March 17, 2023

**Aurora Reference**  
DA-2062-32  
Case No. 2022-6020-00  
RSN: 1618676

**RE: The Aurora Highlands Parkway Phase 2 ISP  
First Review Comment Response Letter**

ASSHTO template for fire truck (above) similar in size to Bronto-type fire truck (below) used in turning template analysis

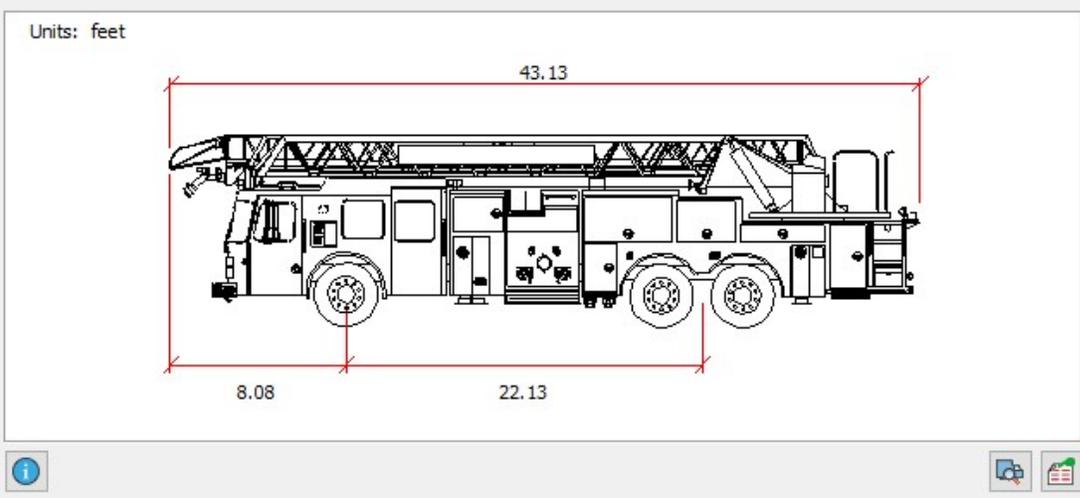
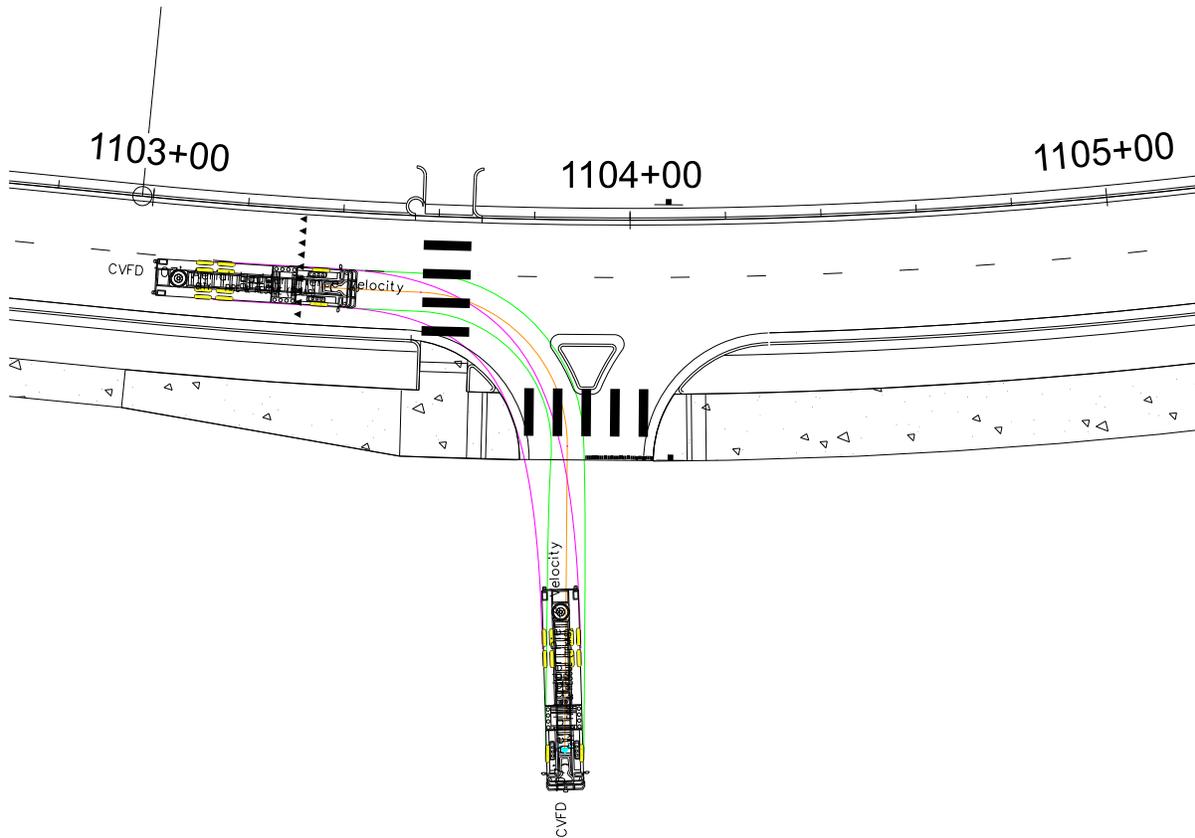
wpolk	49	C-04	Please verify proposed fire hydrant spacing. It appears that multiple hydrants are spaced beyond the 500'. If this is the case, please revise spacing to be on average every 500'.	A	Fire hydrant spacing has been revised to 500'.	Water
Bickmire	50	C-04	show/label existing drainage easement and include rec #	A	Added where applicable	Drainage
Bickmire	51	C-04	Remove if these are no longer there	A	Removed	Roadway
Bickmire	52	C-04	Will this fence be installed by the developer or the builder?	A	by the developer	Roadway
Rnelson	53	C-04	Label Subdivision and provide recording information (Typical)	A	Added where applicable	Roadway
Bickmire	54	C-04	remove lot lines	A	Removed	Roadway
Rnelson	55	C-04	Add line type to the legend and label if this is a section line?	A	Added to legend	Roadway
Rnelson	56	C-05	Label Subdivision and provide recording information?	A	Added where applicable	Roadway
wpolk	57	C-05	Please verify this median meets the COA Roadway standards or provide a Bronto Fire Apparatus turning template. TYP of pork chop medians.	A	Verified, see attached references	Roadway
